ENGINE COMPONENTS, INC.

S.I. No.: **98-5-2**

Title: ALTERNATE MEANS OF COMPLIANCE: CRANKSHAFT GEAR RECESS REPAIR

Revision: **5 (11/15/06)**

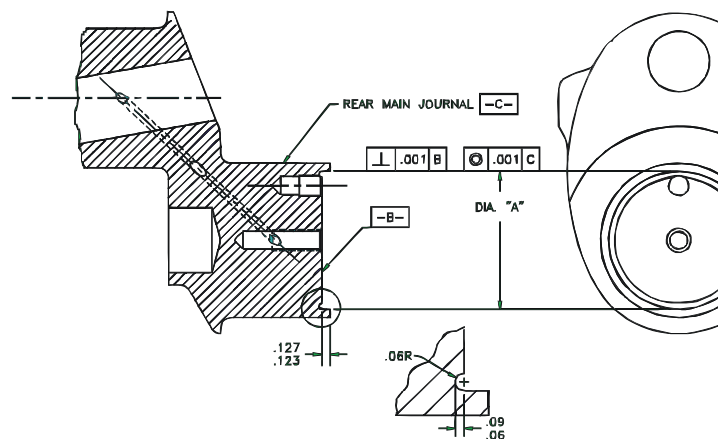
The repair procedure is to machine or grind the crankshaft gear pilot bore (Diameter "A" in the illustration below) to one of the oversize dimensions shown in Table 1. The pilot bore diameter must be maintained perpendicular to the bottom of the recess and concentric with the rear main journal within .001 TIR. The surface roughness of the pilot bore must be not greater than 32 micro-inches Ra.

TABLE 1		
Gear P/N	Gear Flange Outside DIA.	Pilot Bore Inside DIA. "A"
AEL19646P005 AEL19647P005 AEL19648P005 AEL19649P005	2.1300-2.1305	2.130-2.131
AEL19646P010 AEL19647P010 AEL19648P010 AEL19649P010	2.1350-2.1355	2.135-2.136
AEL19646P015 AEL19647P015 AEL19648P015 AEL19649P015	2.1400-2.1405	2.140-2.141
AEL19646P020 AEL19647P020 AEL19648P020 AEL19649P020	2.1450-2.1455	2.145-2.146

NOTE: CHECK GEAR CLEARANCE IN CRANKSHAFT BORE. THE FIT SHALL BE FROM .001 INCH LOOSE TO .0005 INCH TIGHT.

NOTE: THE CRANKSHAFT FLANGE SHOULD BE PERMANENTLY MARKED WITH THE OVERSIZE IDENTIFICATION GB-P005, GB-P010, GB-P015, OR GB-P020.
